**CHANGE ORDER APPROVAL FORM**

PROJECT: Henry Smith Road Improvements Project

CHANGE ORDER NUMBER: 01

**Change Order No. 0001**

REVISIONS				ENGINEER OF RECORD		NASSAU COUNTY ENGINEERING	ROADWAY PLAN	SHEET NO.
DATE	DESCRIPTION	DATE	DESCRIPTION	DOW W. PETERS III, P.E. LICENSE NUMBER 65565 PETERS AND YAFFEE, INC. 9822 TAPESTRY PARK CIRCLE, SUITE 205 JACKSONVILLE, FL 32246		CONSTRUCTION PLANS FOR:		20
						HENRY SMITH ROAD

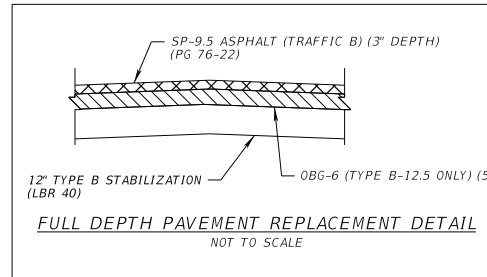
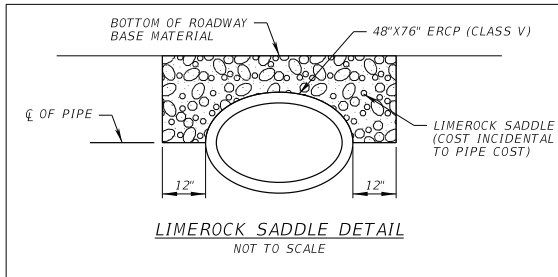
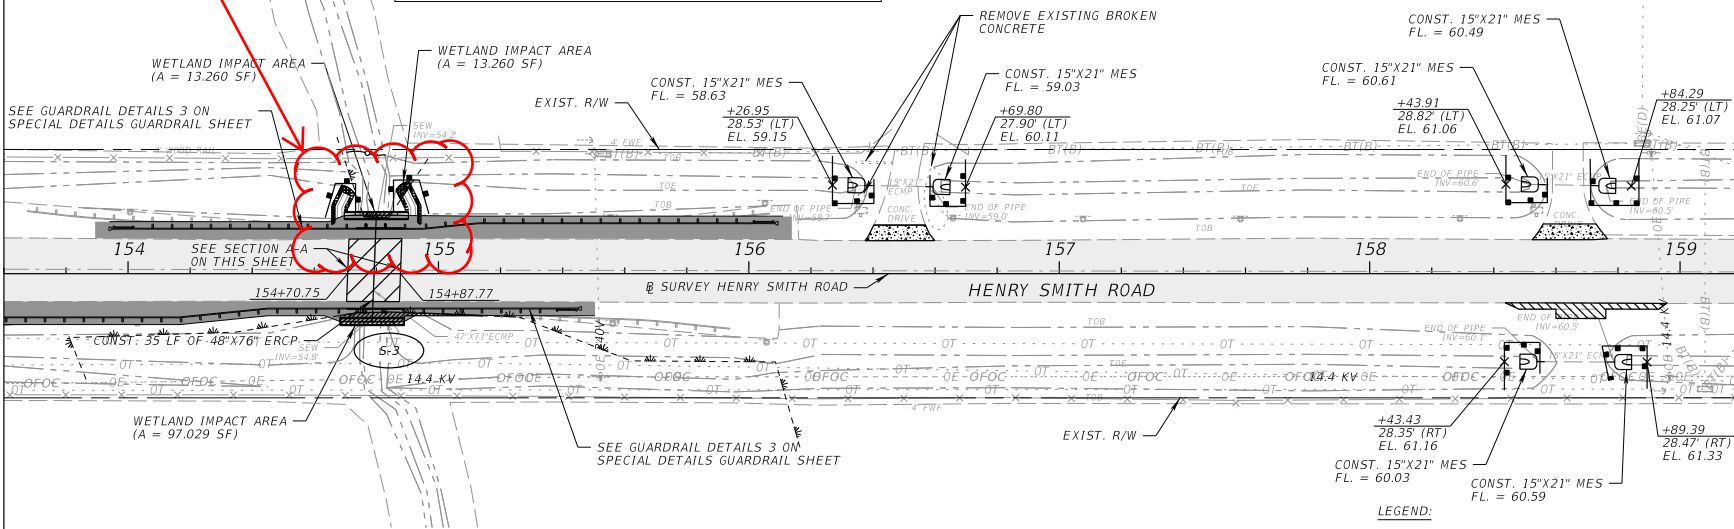
Omit riprap, bedding stone, and ditch pavement between 154+60 and 155+00 LT

REVISIONS				ENGINEER OF RECORD		NASSAU COUNTY ENGINEERING	ROADWAY PLAN	SHEET NO.
DATE	DESCRIPTION	DATE	DESCRIPTION	CONSTRUCTION PLANS FOR:		HENRY SMITH ROAD		22
				DOW W. PETERS III, P.E. LICENSE NUMBER 65565 PETERS AND YAFFEE, INC. 9822 TAPESTRY PARK CIRCLE, SUITE 205 JACKSONVILLE, FL 32246

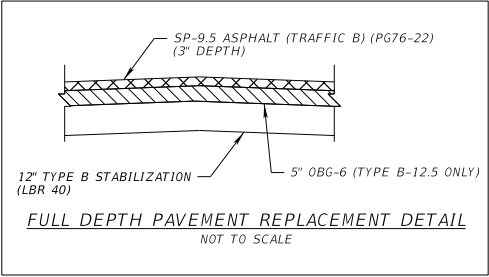
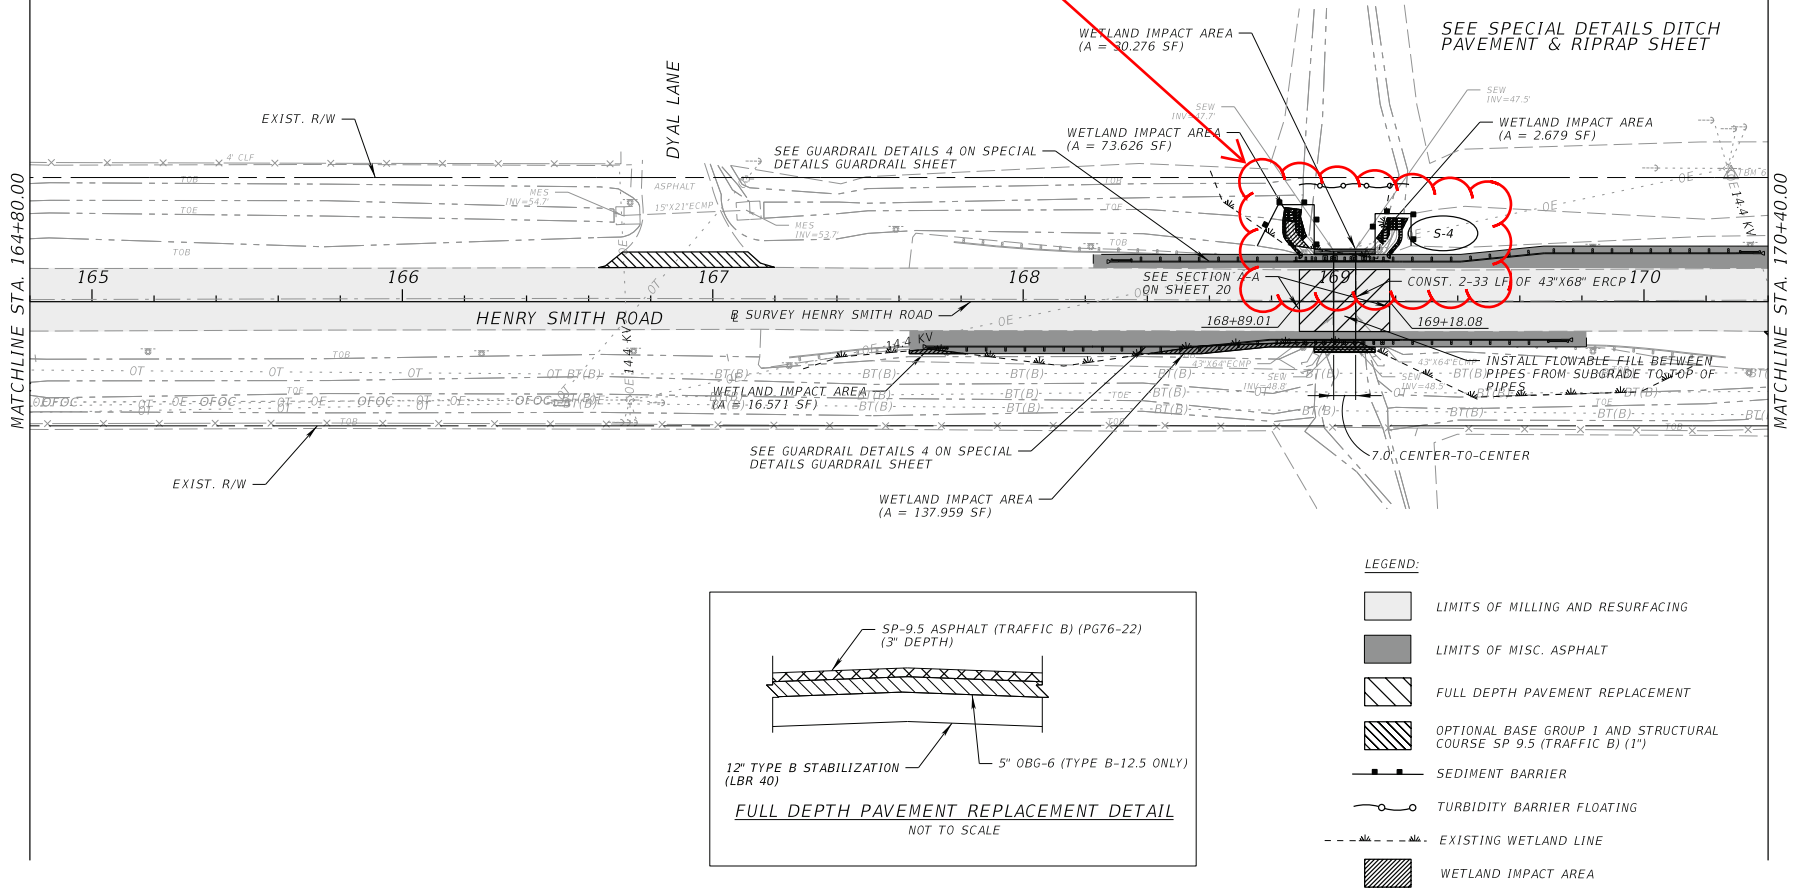
Omit riprap, bedding stone, and ditch pavement between 168+80 and 169+40 LT

NASSAU COUNTY ENGINEERING	<i>SPECIAL DETAILS</i> <i>DITCH PAVEMENT &amp; RIPRAP</i>	SHEET NO.
	CONSTRUCTION PLANS FOR:  HENRY SMITH ROAD		31

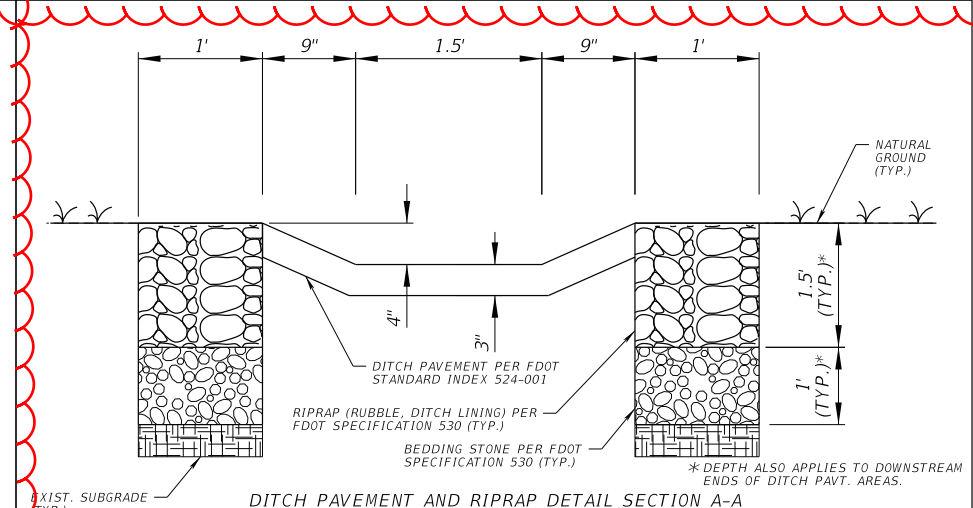
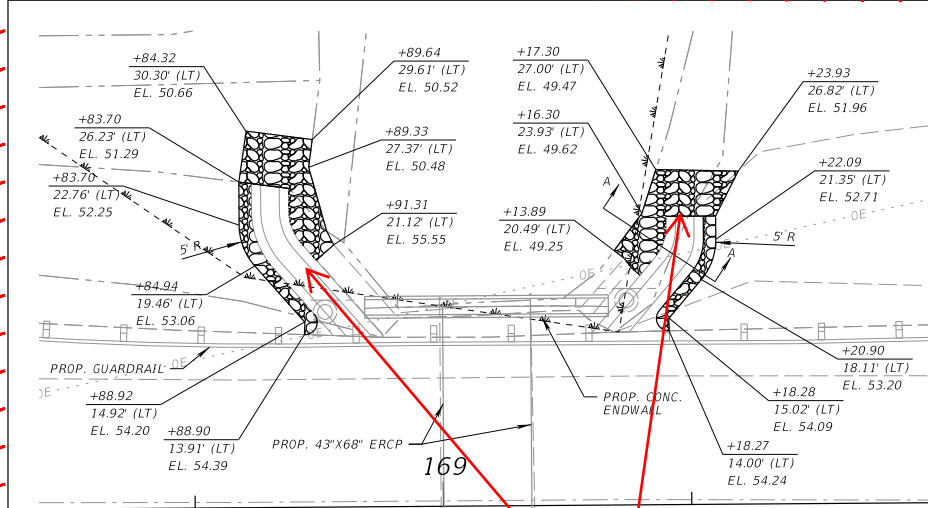
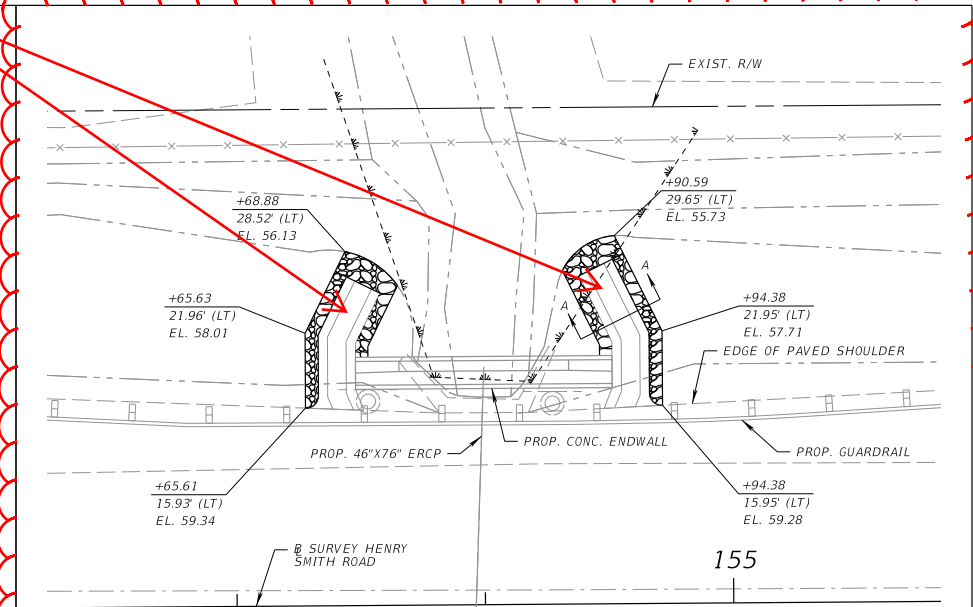
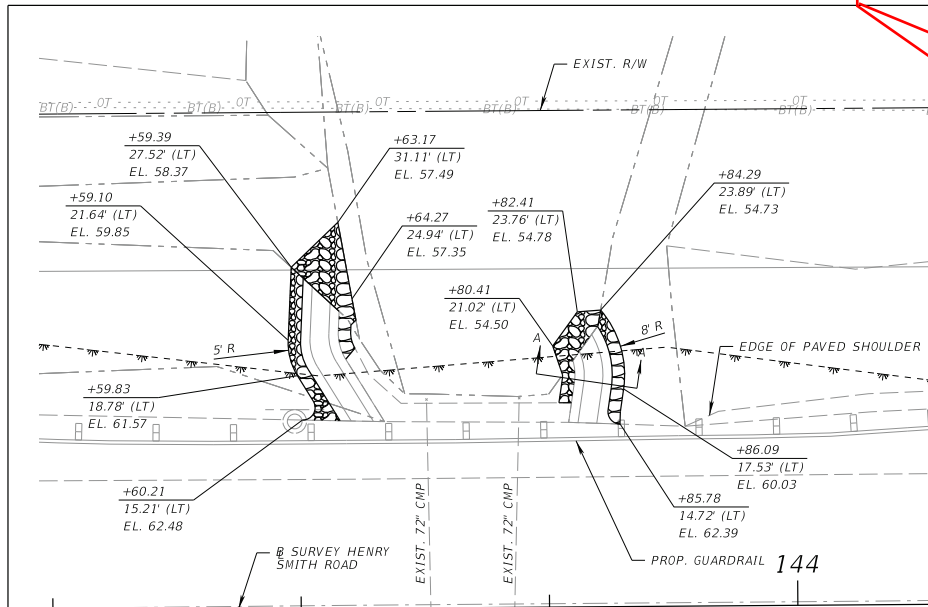
Omit riprap, bedding stone, and ditch pavement between 154+60 and 155+00 LT

Omit riprap, bedding stone, and ditch pavement between 168+80 and 169+40 LT
